NORTH WATERFRONT COVE LLC

We write to respond to questions raised by the Engineering Criteria Review Board of the BCDC in a meeting on January 24, 2019 related to the seismic safety of the Northern Wharf Structure at the proposed Encinal Terminals Development in Alameda, California.

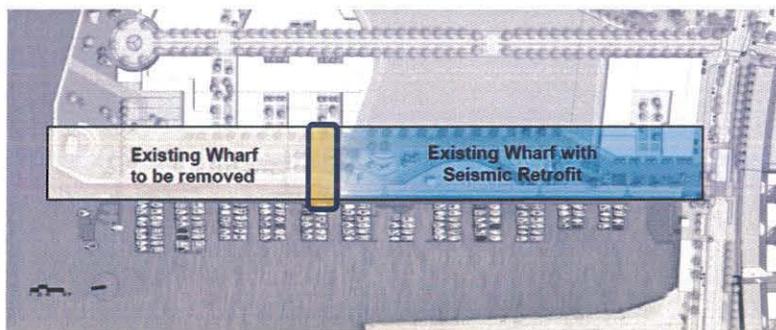
The design team had also indicated to the ECRB that the non-retrofitted portions of the wharf that were founded in 40-feet or more of Young Bay Mud at the Northern end of the site were at risk of collapse and could not be feasibly modified to prevent collapse during the large scale seismic event specified in the approved criteria. During the January 24, 2019 ECRB meeting, concerns were raised by the board members regarding the safety of the non-retrofitted wharf, specifically with regard to allowing public access on a portion of wharf that cannot meet the same seismic standards as the retrofitted portion. Because the ECRB could not recommend allowing public access to this portion of the wharf, it was suggested that we work with staff and further evaluate the safety of those portions of the wharf (Northern wharf) that are infeasible to retrofit, to see if public access was safe.

To address the concerns, the design team evaluated the impacts to the Northern wharf area under multiple seismic scenarios. It was determined through this study that, without a retrofit scheme for the Northern portion of the wharf, there is no significant seismic event in which the design team could guaranty non-collapse and therefore could not guaranty life safety. This public safety concern cannot be feasibly overcome by modifying the existing structure and represents an untenable liability to the development team. Since the safety of future occupants on that portion of the Northern wharf cannot be guaranteed, public access to a waterfront promenade cannot be allowed on that portion of wharf.

The Northern wharf will ultimately be demolished, at approximately Station 10+00 (shown below in orange). Total Northern concrete wharf demolition in this area is approximately 70,000 s.f. Station 10+00 was selected because it is the area where ENGEO has safely determined that the Young Bay Mud horizon is less than 40', and where the retrofit scheme can be utilized. If there is a period of time when the southern portion of the retrofitted wharf has been completed

and is accessible, but before demolition on the Northern wharf has been completed, the Northern wharf will be fenced off and access denied to it, until it is removed.
